Docket Item #13
BAR CASE# 2004-0112

BAR Meeting
July 21, 2004

ISSUE: Alterations
APPLICANT: Barbara J. Kaye
LOCATION: 420 Gibbon Street
ZONE: RM Residential

Figure 2 Proposed West Elevation

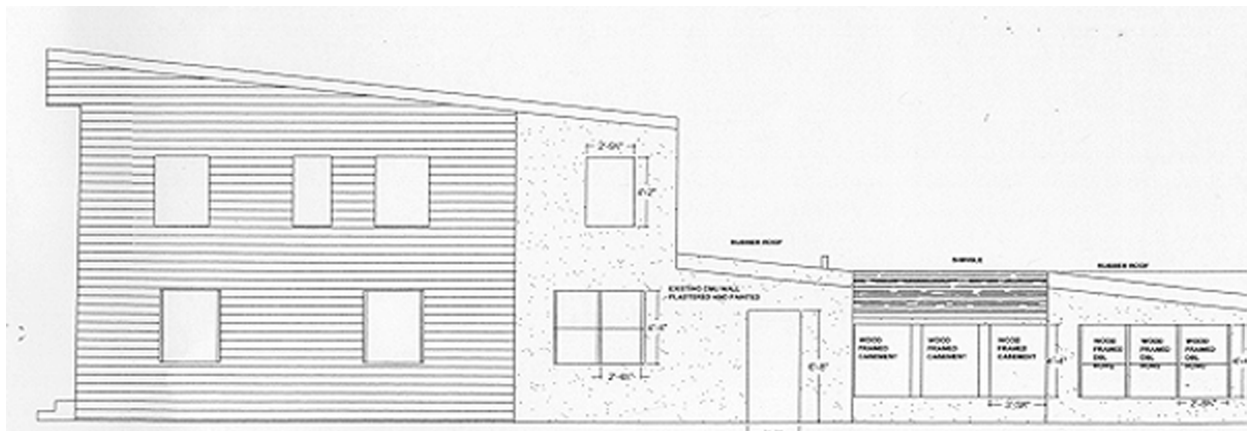
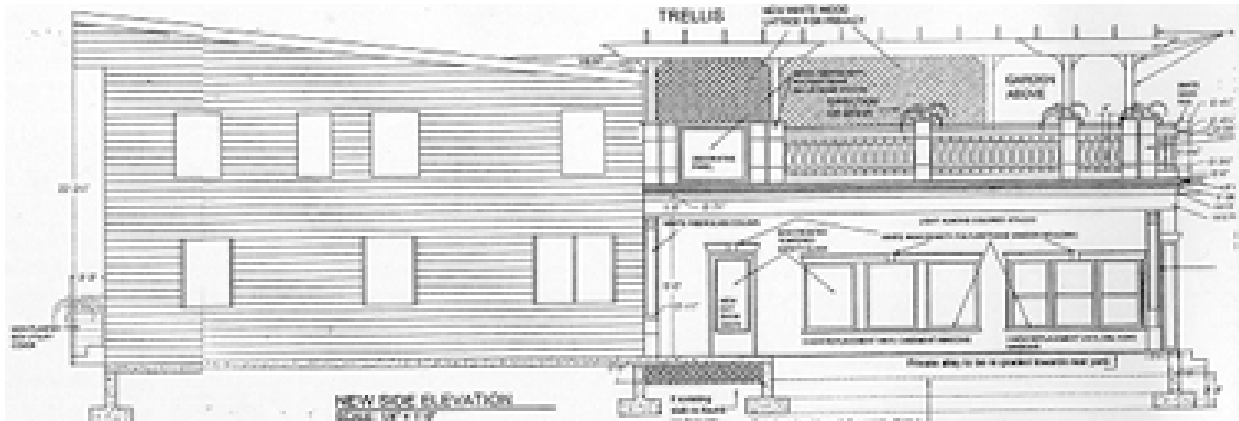
The addition will be covered in light almond colored stucco. The existing wood windows on the addition are proposed to be replaced with new vinyl casement and double hung windows. Staff notes that since the existing windows are located on the west property line, no changes to the size of the openings is permitted. The windows and the door will have high density polyurethane

Staff does however have a number of concerns with the design and materials of the deck. Staff believes that the rear deck should be simplified so that it respects the main block of the house. For example, Staff would prefer to see simple wood pickets for the deck railing rather than the proposed balusters.

The *Design Guidelines* recommend that decks be constructed of materials which are sympathetic to the building materials generally found in the historic districts (Decks -page 3). Although the rear addition is only minimally visible, Staff believes that the vinyl windows and use of synthetic materials is not appropriate.

Therefore, Staff recommends approval of the alterations to the north elevation and deferral of the alterations to the rear additions for restudy of a simpler design using traditional materials.
